**Bulletin No 2016-4 dated 1<sup>st</sup> July 2016 for the  
HONDA GX160 CADET TECHNICAL REGULATIONS:**

**4 Exhaust (for Honda Cadet DEP001) addition to regulation:**

Some images of the upgrades are shown below.

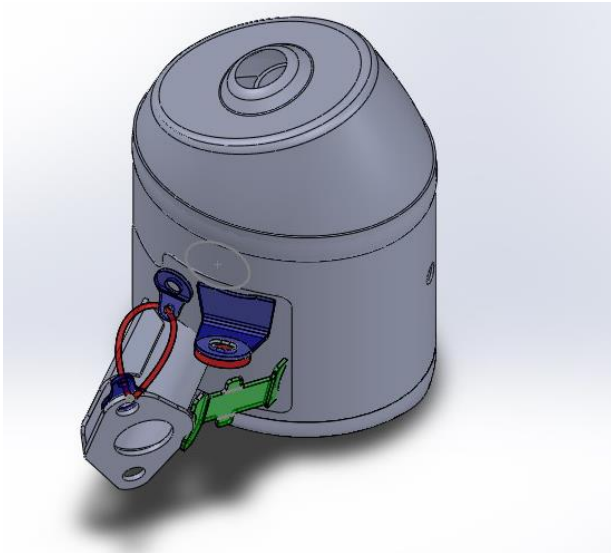
With effect from 29<sup>th</sup> July 2016 all DEP001 exhausts must have been upgraded\* by the manufacturer with the following:

1. Additional welding on exhaust support plate
2. Additional support stay from flange to exhaust body (green)
3. Fixed leash/tether from an eyelet on the exhaust to the flange mounting stud
4. Addition support bracket (blue) with vibration washer (red)

The use of this mounting is not mandatory but is advised. This support bracket is designed to reduce the possibility of exhaust movement and eliminate any distortion to the exhaust flange. If used the vibration washer must be fitted between the exhaust bracket and the rocker cover. It is also advisable to fit a thread recovery procedure in the rocker cover mounting thread. Most engine preparers offer this service. (non-use of this bracket will invalidate any manufacturer's warranty).

The thickness of the flange plate as shown in the Honda GX160 Technical Regulations item 4, currently 4.7mm, is reduced to 4.5mm. (The previous dimension could be marginal on some exhausts).
